**TECHNICAL MEMORANDUM**

Subject: ZC Case No. 14-12E: 1329 5<sup>th</sup> Street NE Second-Stage PUD of Clarion Gables Multifamily, L.P. and EAJ 1309 5<sup>th</sup> Street, LLC (collectively, the “Applicant”) – Comprehensive Transportation Review Update

Figure 2: Location of Potential Future Knock-Out Panels

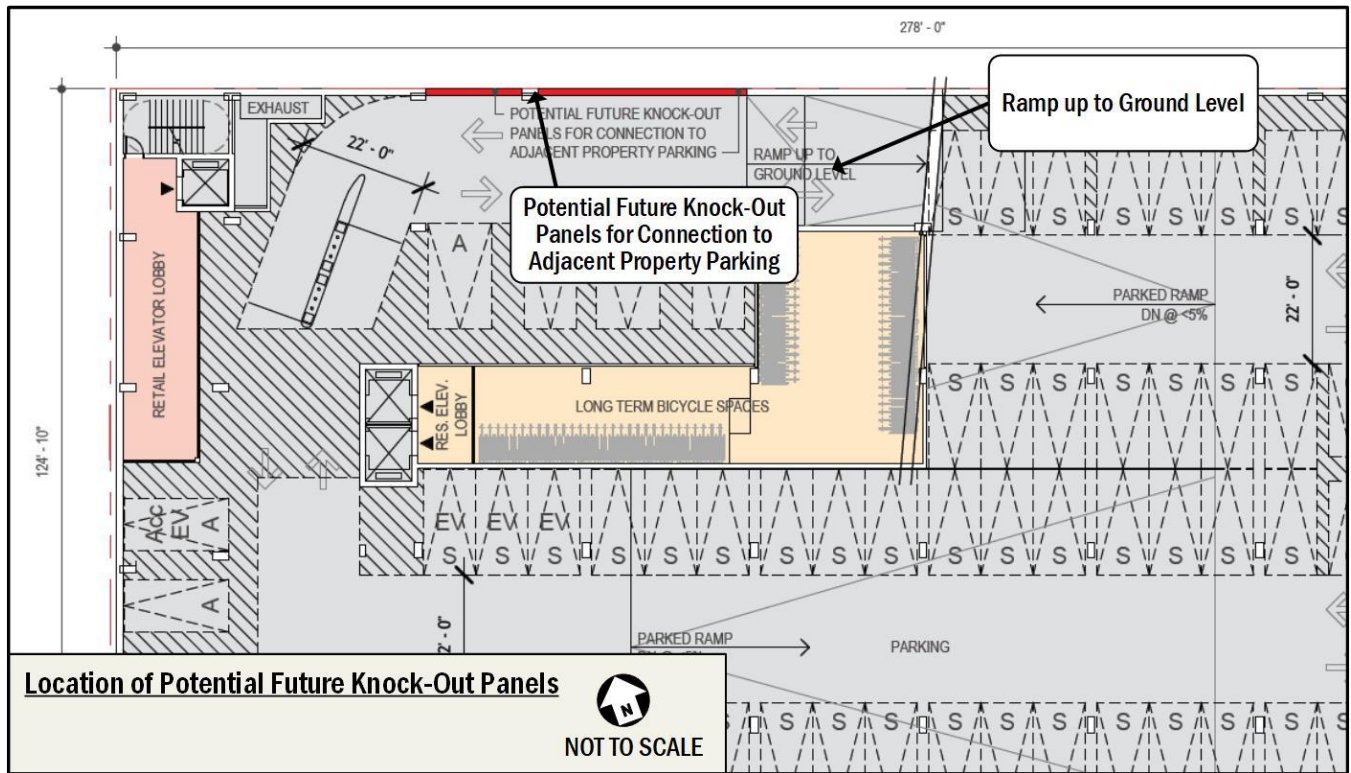
Per DDOT's request, the Applicant has explored incorporating into the North Building a design strategy that could accommodate shared vehicle access with the proposed enclosed garage serving the neighboring property immediately to the north of the North Parcel (i.e., so-called "Parcel 4" of the 6<sup>th</sup> Street Development, which is subject to a First-Stage PUD approved in Z.C. Case No. 15-24 and which is under control of an owner and developer that is unaffiliated with the Applicant. Parcel 4 has its primary vehicular access from 5<sup>th</sup> Street, NE as approved by a First Stage PUD on such site). The potential future shared access would allow for 5<sup>th</sup> Street, NE to occasionally be closed to vehicular traffic for special events while still allowing vehicular access to the garage for Parcel 4. In order to allow for this scenario, the Applicant will design and construct the North Building's garage with a "knock-out" panel that could be removed to allow access between 6<sup>th</sup> Street, NE and the Parcel 4 garage via the North Building's garage, as shown in Figure 2.

The current set of drawings for the North Building contain a wide area of knock-out panels where the neighbor could elect to place a vehicle entrance subject to reaching an agreement with the Applicant in the future governing the conditions of such access.
